RE: **Grants Reclamation Project – DP-200 Renewal – Response to September 12, 2000 NMED Letter Transmitting Comments / Questions on Renewal Application**

**HOMESTAKE MINING COMPANY
Grants Reclamation Project
DP-200 Renewal**

**RESPONSES TO
NEW MEXICO ENVIRONMENT DEPARTMENT
REGARDING QUESTIONS / COMMENTS ON DP-200
RENEWAL APPLICATION
PER
NMED LETTER DATED SEPTEMBER 12, 2000**

FIGURE 11. MOLYBDENUM CONCENTRATIONS FOR BACKGROUND WELLS P, P1, P2, P3 AND P4.

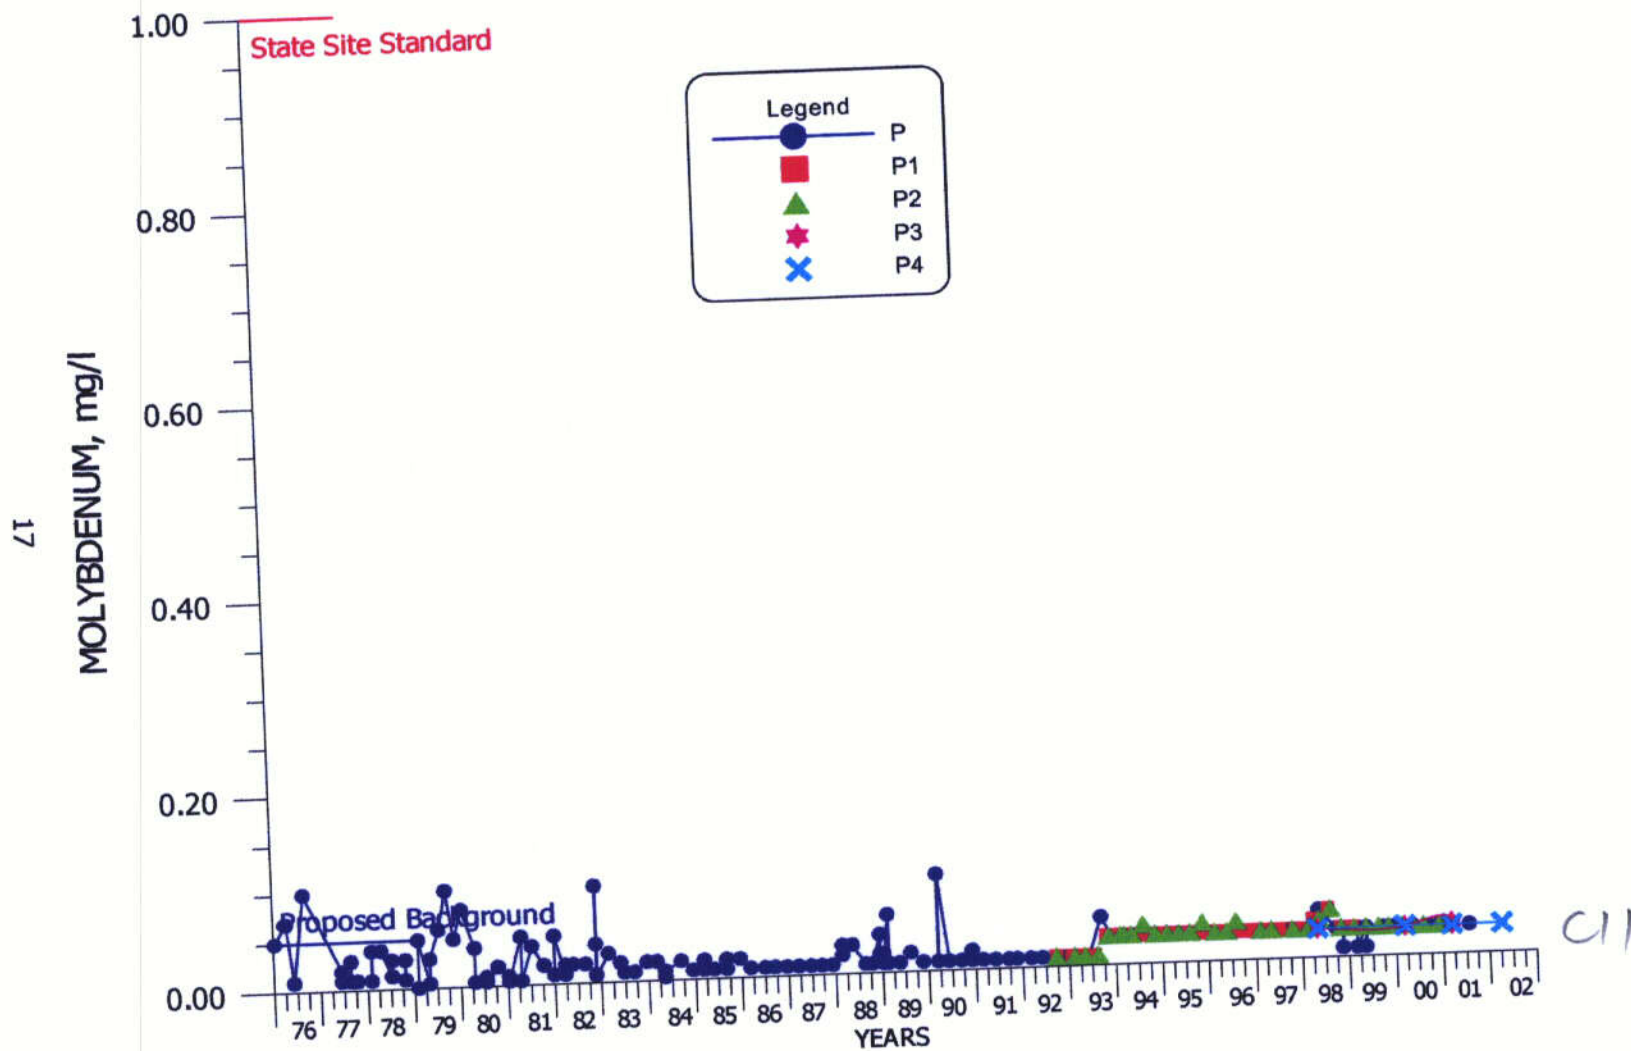
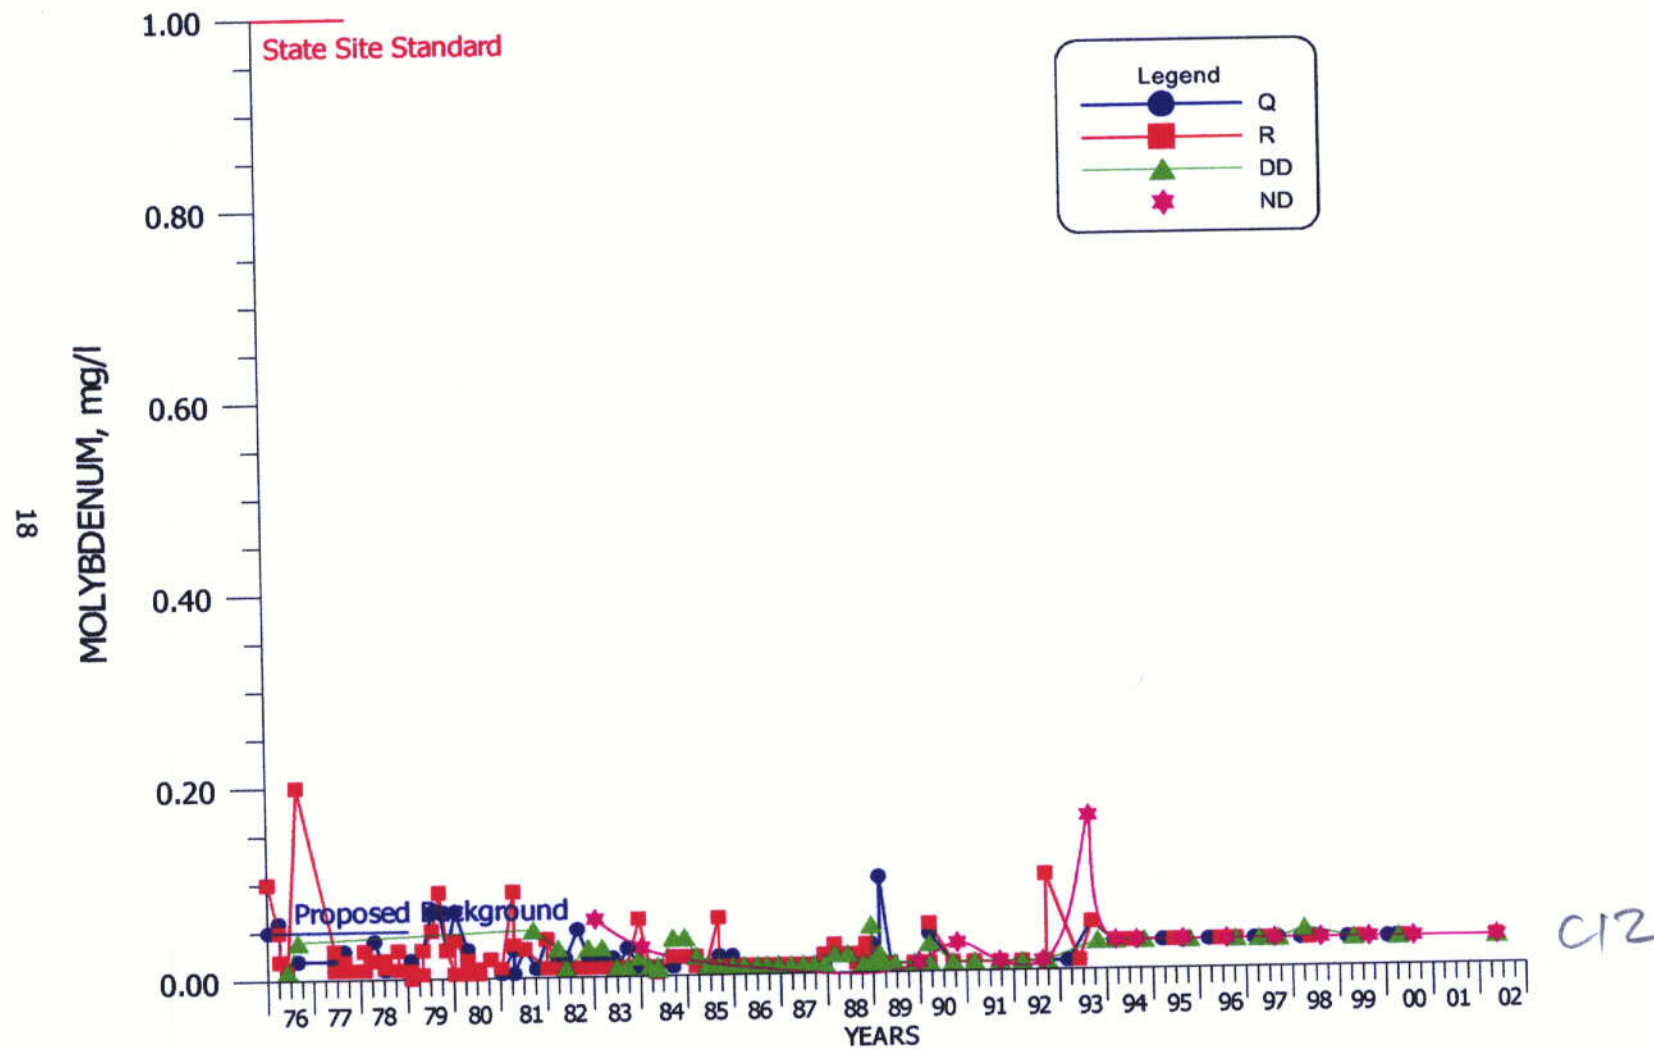
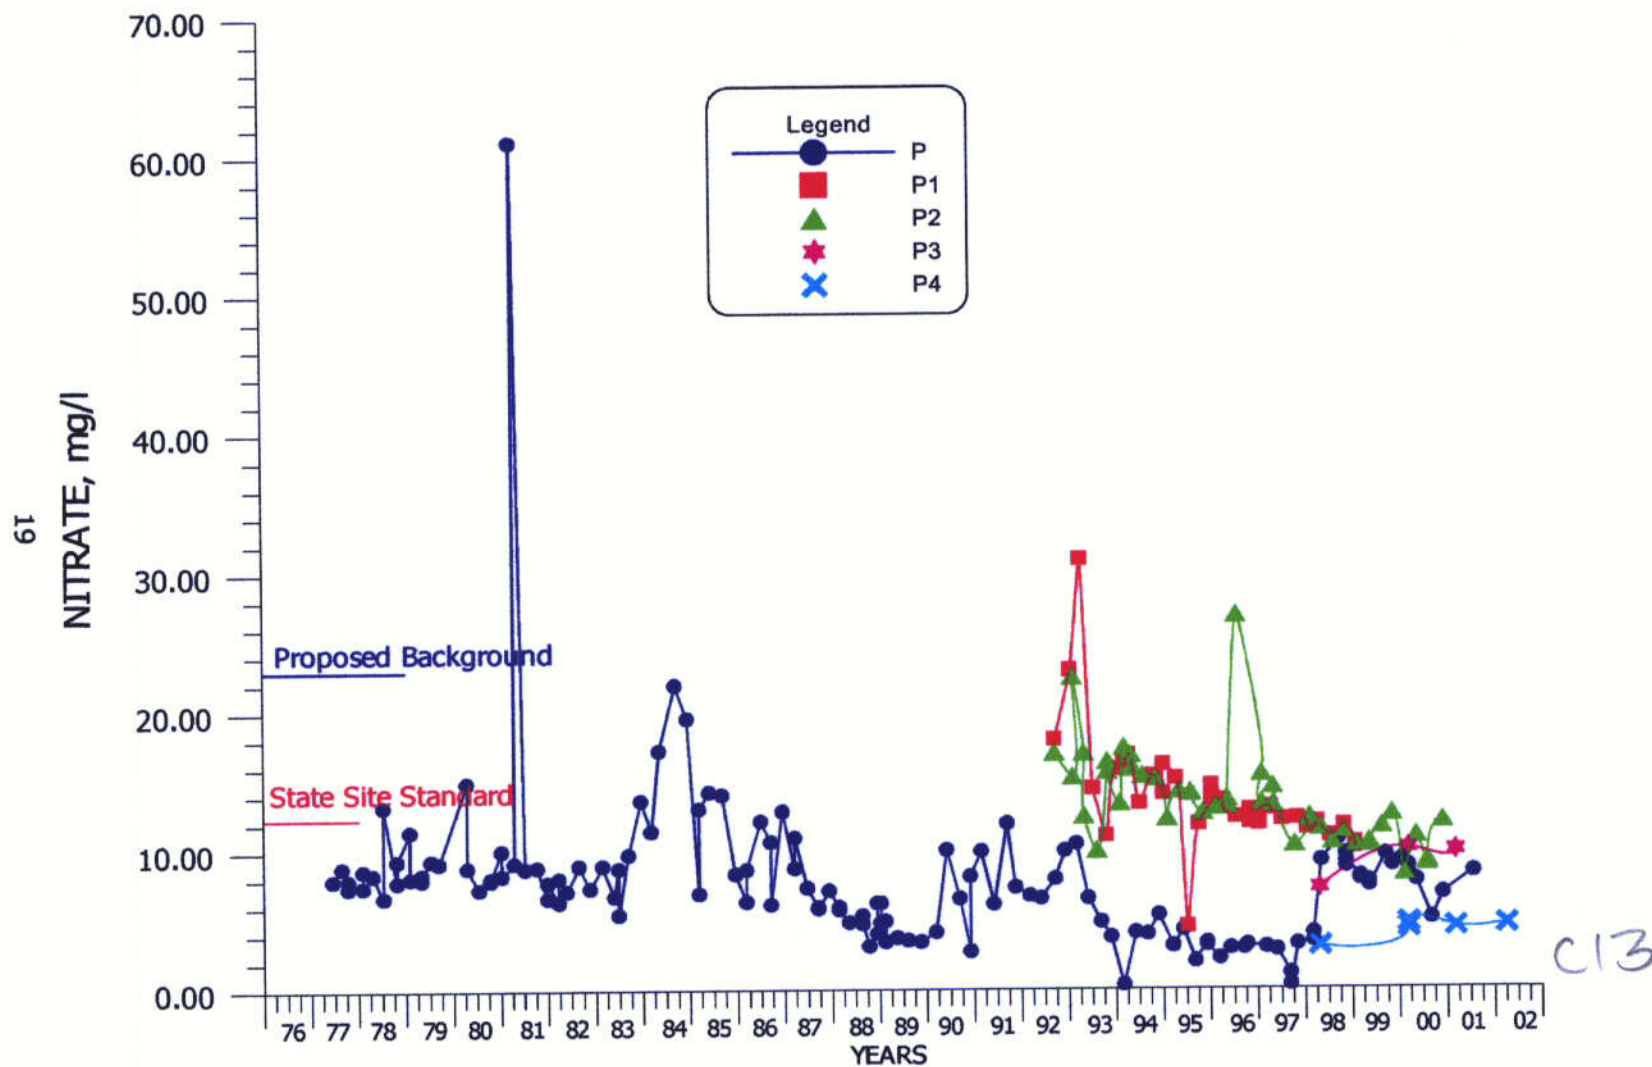
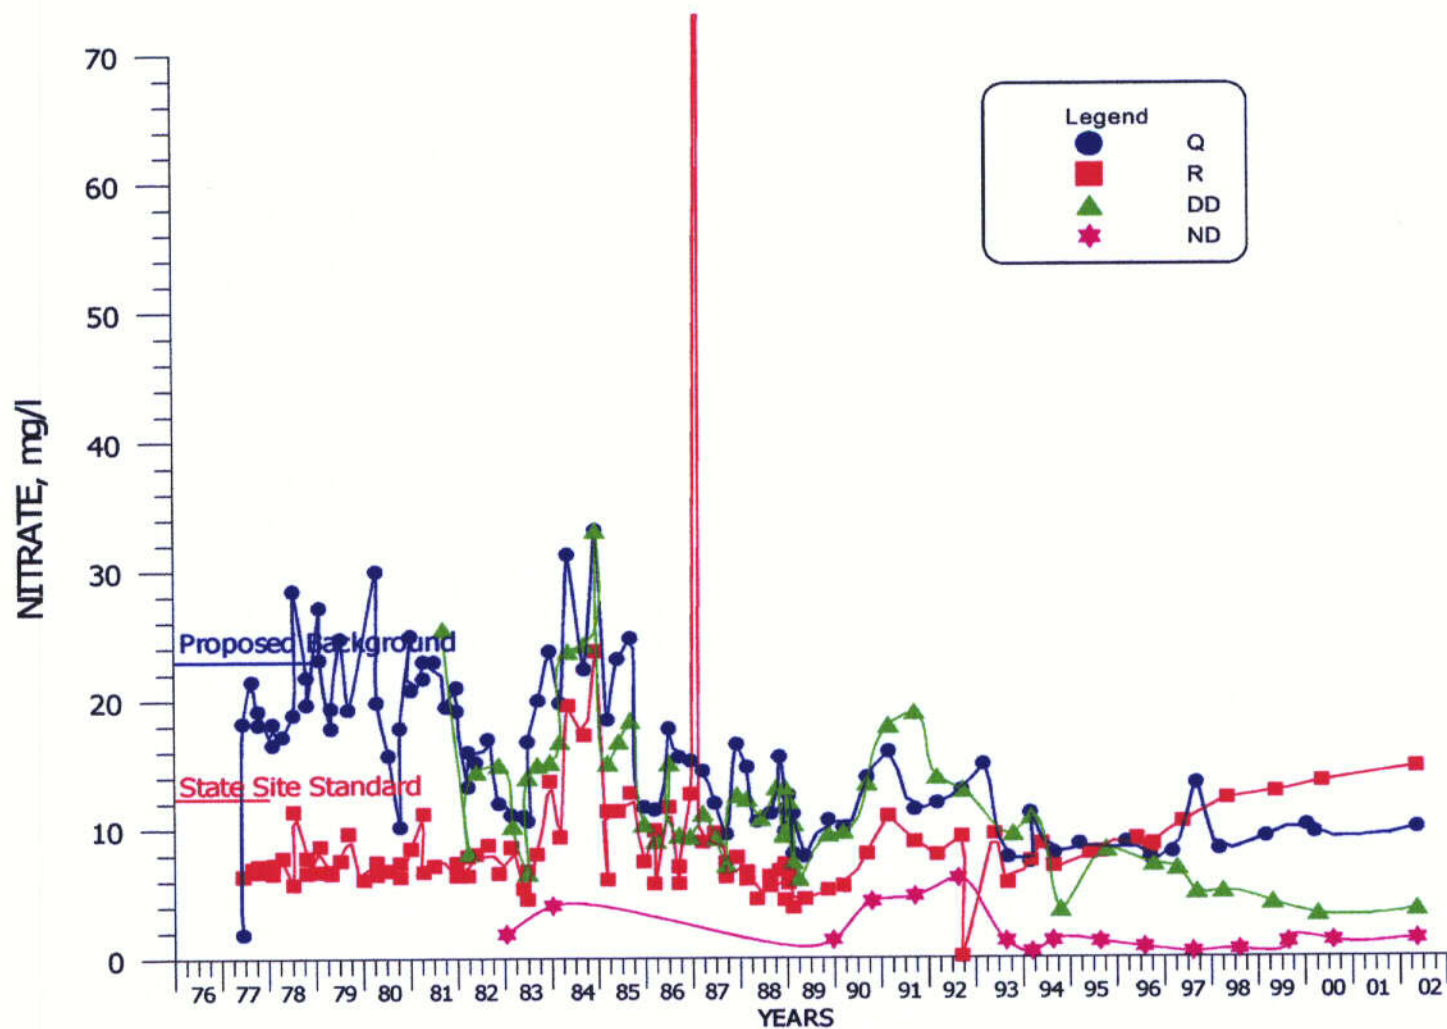
Comment: II.4. Water Quality Trends in Near Upgradient Wells

Comment: II.5.A. Graphs for Near Upgradient Data

Response: Plots of historical water quality for TDS, chloride, uranium, selenium, molybdenum and nitrate were developed for wells P, Q, R, DD, ND, P1, P2, P3 and P4 at the same vertical and time scales. The 5 'P' wells are grouped together because they are in the same vicinity of the alluvial aquifer. The remaining four background wells, which are west, north and east of the 'P' wells, are shown on the second plots. The historical plots of water-quality concentrations for the 9 background wells are presented in the enclosed figures according to the following list:

Constituent	FIGURE NUMBER	
	P Wells	Non-P wells
SO4	1	2
TDS	3	4
Cl	5	6
U	7	8
Se	9	10
Mo	11	12
NO3	13	14

The present State site standard was determined from the mean concentrations for upgradient wells P, Q and R for data from 1976 through early 1983. These mean concentrations are presented in Table 2 of the NMED's Pre-hearing Ground-water Discharge Plan Analysis for the Homestake Uranium Mill near Milan, New Mexico, published in January 1984. The use of the mean concentrations does not define the upper portion of the natural background concentrations. Also, the much shorter record does not account for the historical changes that have been observed over the last 24 years. The additional near background wells also better define the natural areal variation in the alluvial aquifer. Therefore, the present statistical analysis of full background is a much more appropriate way to define the site standards at the Grants site.
